**SOLICITATION AMENDMENT  
MODIFICATION DE L'INVITATION**

<b>Title - Sujet</b> Trash Extraction Building Trash Extraction Building – Stony Mountain Institution - Stony Mountain, MB	
<b>Solicitation No. - N° de l'invitation</b> ET025-230135/A	<b>Amendment No. - N° modif.</b> 001
<b>Client Reference No. - N° de référence du client</b> CSC-ET025-230135	<b>Date</b> 2022-06-01
<b>GETS Reference No. - N° de référence de SEAG</b> PW-\$PWU-201-12246	
<b>File No. - N° de dossier</b> PWU-2-45003 (201)	<b>CCC No./N° CCC - FMS No./N° VME</b>
<b>Solicitation Closes - L'invitation prend fin</b> <b>at - à 02:00 PM</b> Mountain Daylight Saving Time MDT <b>on - le 2022-06-14</b> Heure Avancée des Rocheuses HAR	
<b>F.O.B. - F.A.B.</b> <b>Plant-Usine:</b> <input type="checkbox"/> <b>Destination:</b> <input type="checkbox"/> <b>Other-Autre:</b> <input type="checkbox"/>	
<b>Address Enquiries to: - Adresser toutes questions à:</b> Ho (RPC), Hector	<b>Buyer Id - Id de l'acheteur</b> pww201

This Addendum #1 is to amend the following sections of the Tender Document:

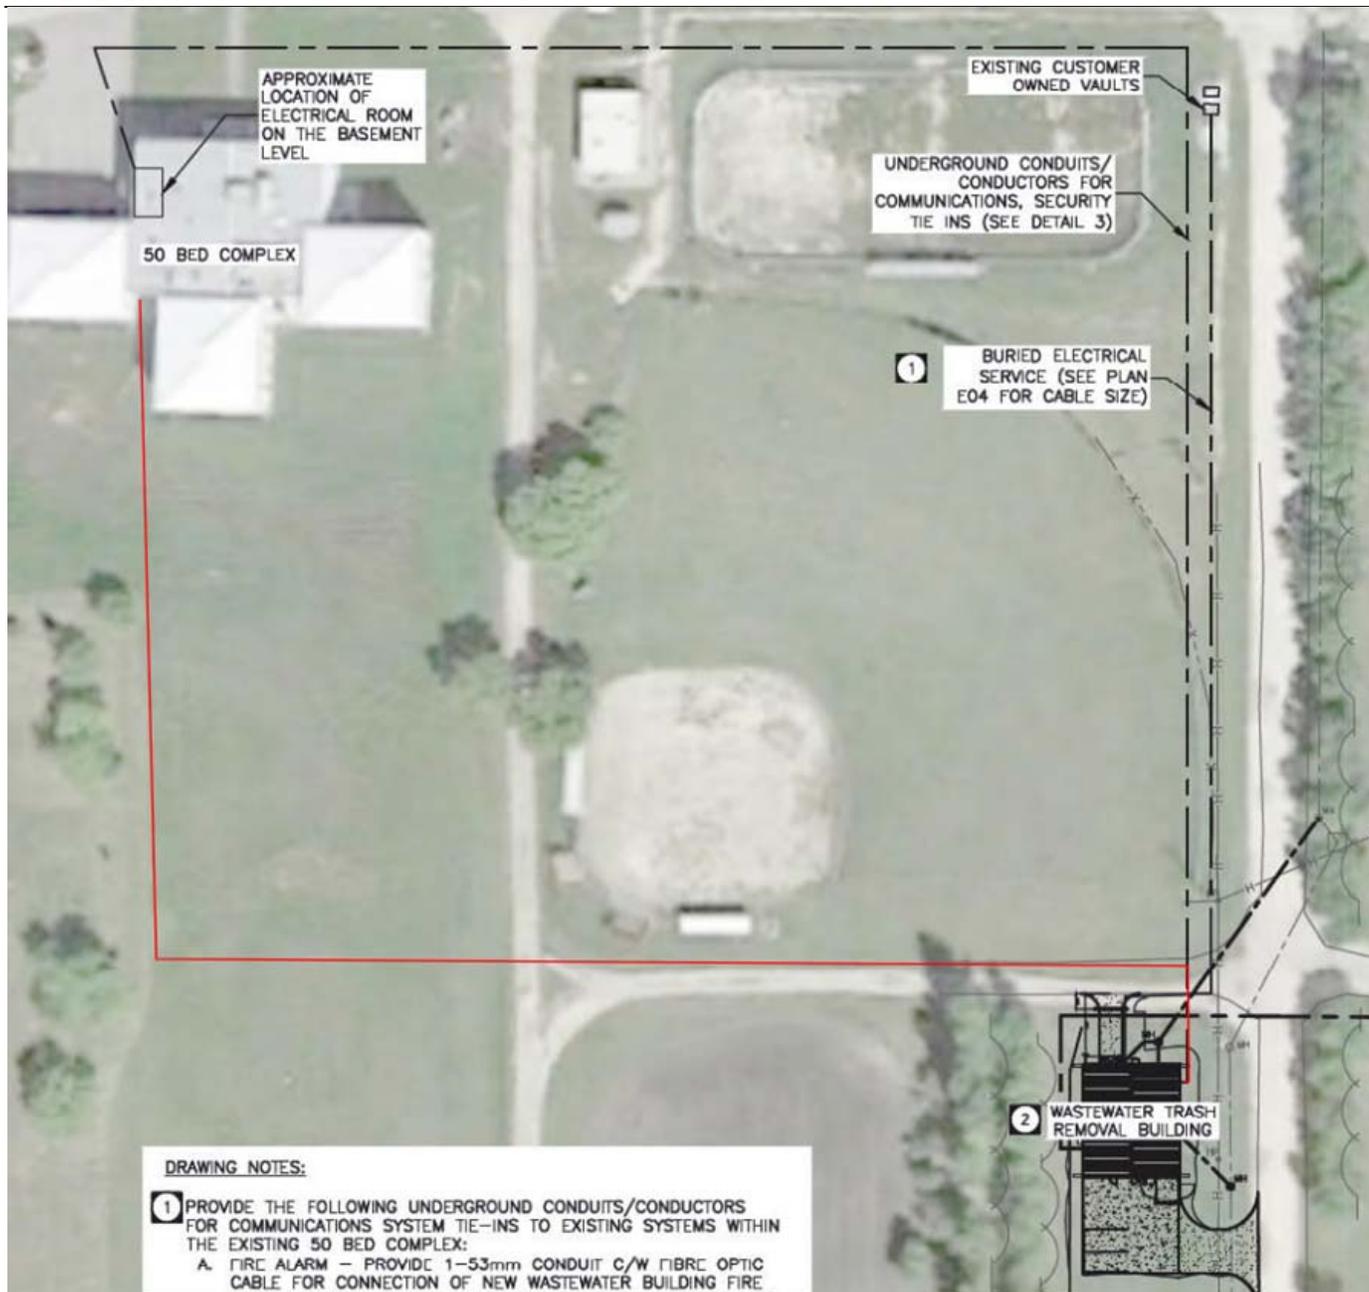
**Q6:** The plan shows buried electrical services to be installed between the new Trash Compaction Building and the existing 50 Bed Minimum Security Housing Unit. I believe there is an existing gas line below grade in the general vicinity of where it is shown to be installed, please see snippet below:

Is it acceptable to install the buried electrical services further West than shown on the plan to avoid the gas line entirely? Perhaps something like this:

**A6:** The route cannot be altered as proposed as it travels through the existing spiritual grounds in the facility. The route alignment on the plan is general and can be adjusted as needed based on site conditions. Final route will be approved by SMI.
